AIRWORTHINESS DIRECTIVE

TYPE AFFECTED: SZD-50-3 Puchacz

SUBJECT: Possible jamming of the rudder control system and modification of the trim tab connection.

DOCUMENTATION: PZL Bielsko Technical Bulletins BE-42/50-3/92 and BR-43/50-3/92 which form part of this AD.

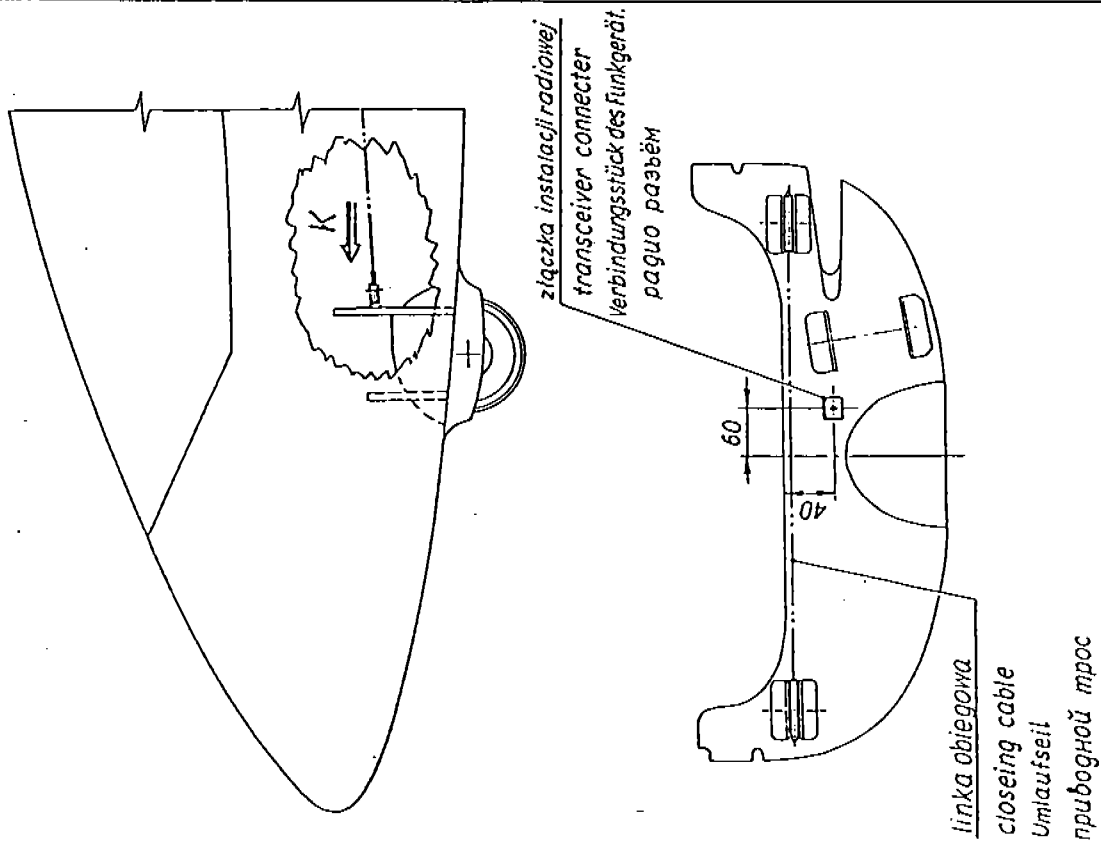
PDPS ZL-BIELSKO"	BULLETIN No BE-42/50-3/92 "PUCHACZ"	Page: 2 of: 3
1. GROUNDS FOR INTRODUCING THIS BULLETIN. ===== This Bulletin has been introduced to avoid the case of jamming of the closing cable of rudder control system onto the transceiver connector fixed on the frame set near the front seat. 2. LIST OF GLIDERS COVERED WITH THIS BULLETIN. ===== All SZD-50-3 "PUCHACZ" type gliders up to the Fact. No B-2052 incl. 3. DESCRIPTION OF INTRODUCED CHANGES. ===== 3.1. It is recommended to check periodically the tension of closing cable in the rudder control system (the decreasing of the tension may cause the above mentioned cable jamming). 3.2. It is proposed to move the transceiver connector acc. to sketch Fig. 1. 4. LIST OF ENCLOSURES. ===== No enclosures. 5. WAY OF INTRODUCING THE CHANGES DESCRIBED IN THIS BULLETIN. ===== 5.1. By way of periodic inspection (e.g. after 50 flying hours) check the closing cable tension. In case the cable slackens adjust it acc. to item 2.2.6 of Technical Service Manual. 5.2. Move the transceiver connector on the frame set near the front seat acc. to the dimensions given on the sketch Fig. 1. 6. FINAL STATEMENTS. ===== The introduction of the recommendations of this Bulletin should be recorded in the Glider Log Book, Chapter: Service Works.

PDPS "PZL-BIELSKO"	BULLETIN No BE-42/50-3/92 "PUCHACZ"	Page: 1 of: 3
BULLETIN No BE-42/50-3/92 "PUCHACZ" Ref: Elimination of the possibility that the closing cable of rudder control system can jam onto the transceiver connector fixed on the frame set near the front seat. Way of introducing: When this Bulletin is obtained. Elaborated in: PDPS-TKE. Director of "PZL-BIELSKO" Dipl. Ing. Jerzy SMUTKIEWICZ This is the translation of the original Polish text approved by the Airworthiness Authority. Translated by W. Stafiej, D.Sc.

1. Before next flight and at each annual inspection the tension of the rudder closing cable must be checked in accordance with section 2.2.6 of the Puchacz Technical Service Manual.
2. At the next annual inspection but before 31 July, 1993 the radio connector must be relocated in accordance with section 5.2 and figure 1 of Technical Bulletin BE-42/50-3/92.
3. At the next annual inspection but before 31 July, 1993 the trim system washer at the tailplane must be exchanged in accordance with Technical Bulletin BR-43/50-3/92.

Fig. 1.

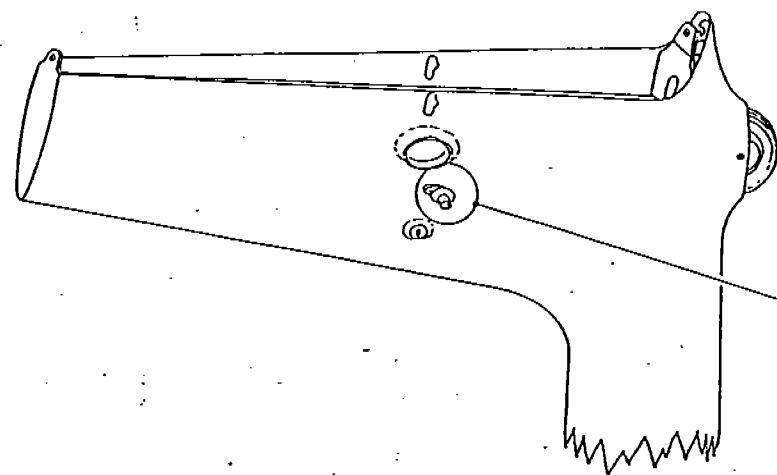
The Bulletin concerns only those SZD-50-3 "PUCHACZ" gliders on which it was found that the washer securing the "central" position when the torque tube is displaced laterally "sinks" into the oval opening in the fin covering (see sketch Fig. 1).

Fig. 2.

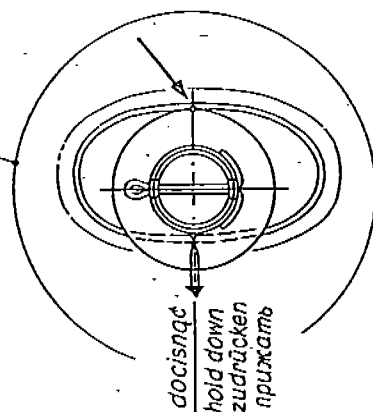
In the necessary cases the special washers ensuring the centralization of the torque tube in respect to the fin should be replaced with the "new" ones having the outer diameter of $\phi 36$ (Drawing 503.63.39.00) - see Fig. 2.

5.1. Having the tailplane disassembled - remove the safety pin $\phi 2,5$ securing the washer against falling down, then remove the washer. Repeat the same on the opposite side.

5.2. Replace the "new" washers ($\phi 36$) and secure with the safety pins.
